Montana's Regional Haze State Implementation Plan for the Second Planning Period
Compilation of Federal Land Manager and Public Comments and Montana's Responses Thereto

APPENDIX F – FEDERAL LAND MANAGER COMMENTS

Montana DRAFT Regional Haze State Implementation Plan (SIP)

Technical Comments

Figure 1. Hourly winds at the West Glacier site during the months of November through March, 2000-2018. Wind speed is shown in meters per second.

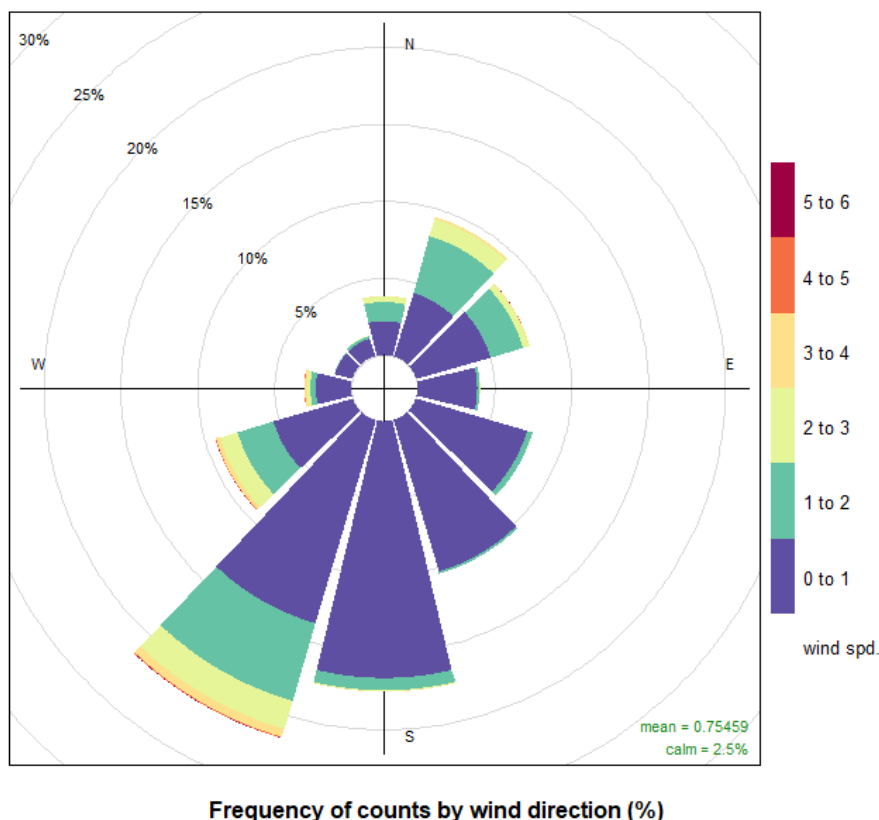
In section 9.1 of the draft SIP, MDEQ raises a question regarding the representativeness of the GLAC1 Interagency Monitoring of Protected Visual Environments (IMPROVE) monitor. This monitor is used to track the visibility progress of Glacier National Park under the Regional Haze Rule. MDEQ notes that there is a park wastewater treatment plant approximately 500 m north-northwest of the monitor and suggests that it may be contributing to elevated wintertime (November-March) nitrate levels. The SIP includes wind roses in MT Draft SIP Figure 9-4 that were created using data from the Glacier International Airport, which is approximately 20 miles from the monitor. The SIP states that winds on the most impaired days during the wintertime come most frequently from the north-northwest, suggesting that the wastewater treatment plant may be contributing to ammonium nitrate concentrations. Figure 9-4 shows that winds are also from the northeast a significant portion of the time,

We plotted wind data from the West Glacier horse stables site, AQS site number 30-029-8001, located at latitude 48.5103 degrees north and longitude 113.9969 degrees west. This site is located inside the park boundary very close to the GLAC1 IMPROVE monitoring location, and it is therefore likely to be more representative of winds at the IMPROVE site than the Glacier airport site. Figure 1 below shows hourly winds during the months of November through March for the years 2000-2018. This figure shows that hourly winds are predominantly from the southwest and south, along with a significant contribution from the northeast. This is not surprising, given the site's location near the end of a narrow valley that runs roughly from southwest to northeast. Winds from the north and northwest occur during only a small percentage of the time.

Figure 2. 24-hour average winds at the West Glacier site during the months of November through March, 2000-2018. Wind speed is shown in meters per second.

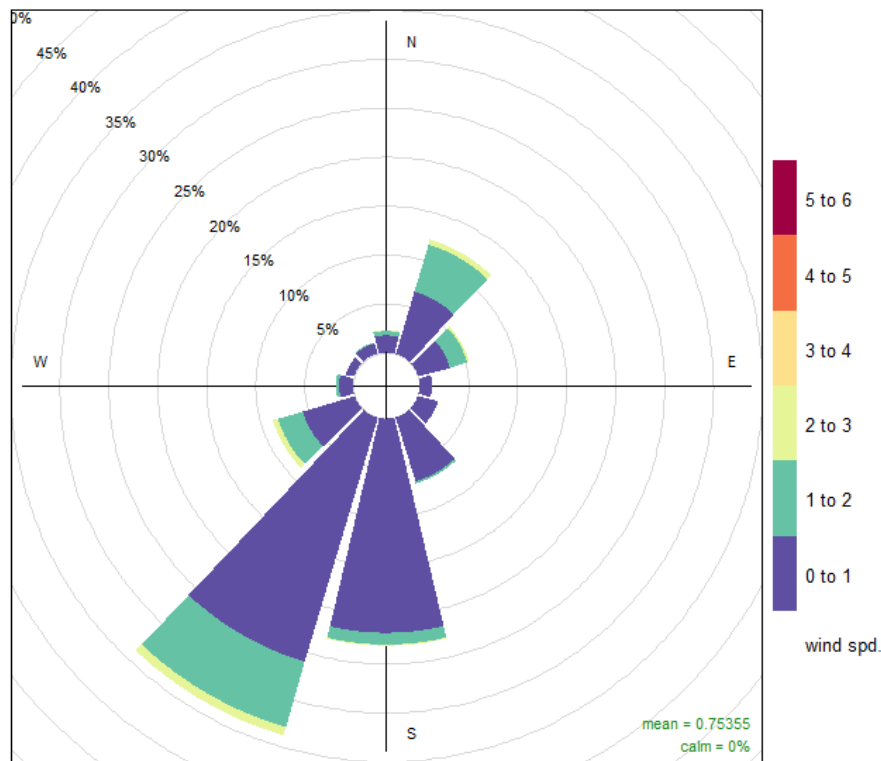
Figure 2 shows 24-hour averaged winds, where again winds from the south and southwest predominate.

Figure 3. Pollution rose showing ammonium nitrate concentration on the most impaired days during all months, 2000-2018. Ammonium nitrate concentrations are in ug/m³.

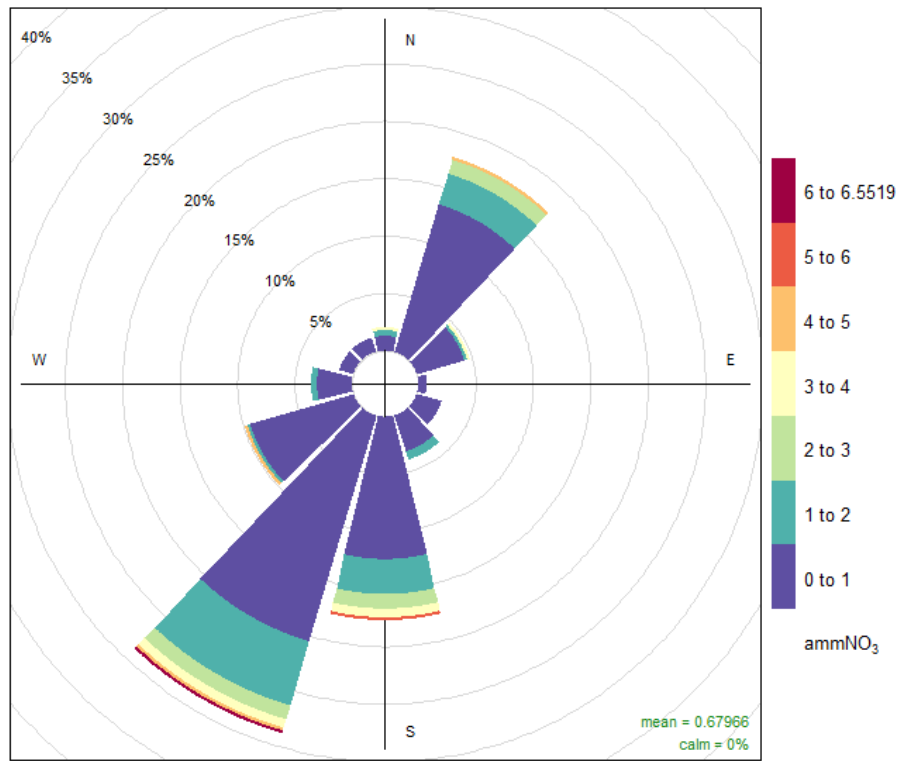
Figures 3 and 4 show pollution roses for ammonium nitrate concentrations measured at the GLAC1 IMPROVE site on the most impaired days in all months (Figure 3) and just the winter months (Figure 4). Both figures show that the highest concentrations are associated with winds from the southwest, which is the direction of Kalispell and the Whitefish Valley. The wastewater treatment plant is located to the northwest of the monitoring site. Given this, we recommend that MDEQ remove this discussion from the draft SIP and refer any further analysis of potential siting considerations for the GLAC1 monitor to the IMPROVE steering committee.

Figure 5. Preheater Cross Section

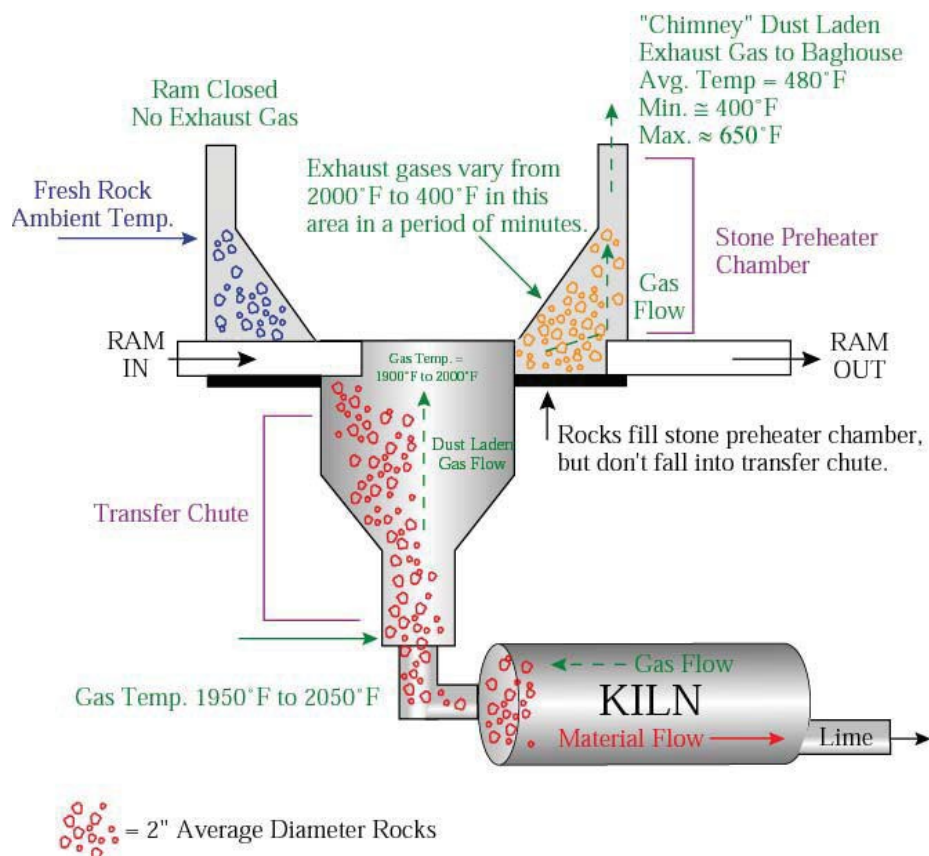
Graymont: Based on the temperature profile, there are three locations in a rotary preheater lime kiln system where the ammonia /urea injection could theoretically occur: the stone/preheater chamber, the transfer chute, or after the PMCD. A fourth location that will be considered in this analysis is the kiln tube. In order for SNCR to be technically feasible, at least one of these locations must meet the following criteria: placement of injector to ensure adequate mixing of the ammonia or urea with the combustion gases, residence time of the ammonia with the combustion gases, and temperature profile for ammonia injection. (Figures 5 and 6 represents a typical lime kiln preheater, and are not specific to the kilns at the Graymont Indian Creek facility.)

Figure 6. Preheater Stone Chamber Temperature Variation with Time and Location

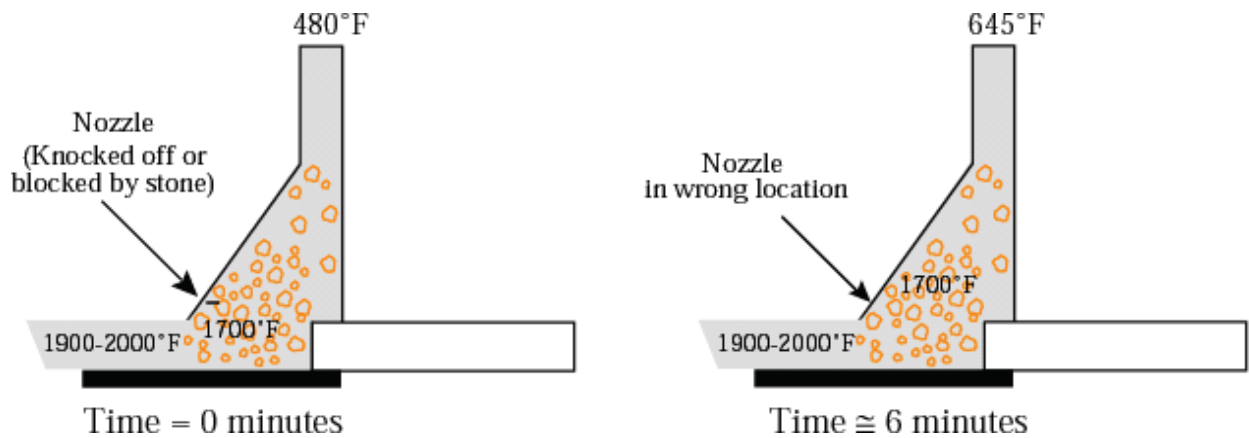
Graymont: The required temperature range for the reaction may occur within the preheater. However, the location of the temperature zone varies with time and location as explained below.

In each Graymont Indian Creek preheater, mechanical rams operate in sequence, transferring limestone, one ram at a time, from the stone chambers into the transfer chute. When a ram is in the "in" position, very little exhaust gas flows through the stone and out the duct. When the ram pulls out, the cold stone drops down and fills the stone heating chamber. The angle of repose of the stone and the configuration of the duct and chamber are such that stone does not continue to fall into the transfer chute. Hot gases, at approximately 1,950°F, then pass through the stone chamber filled with cold stone. The first gas to pass through the chamber exits the chimney at approximately 400°F. As the cold stone heats up, the exit gas temperature increases and reaches a high of approximately 600°F. The ram then strokes and pushes the heated stone into the transfer chute and starts the cycle again. The temperature profile in the stone chamber varies as shown in the figure below.
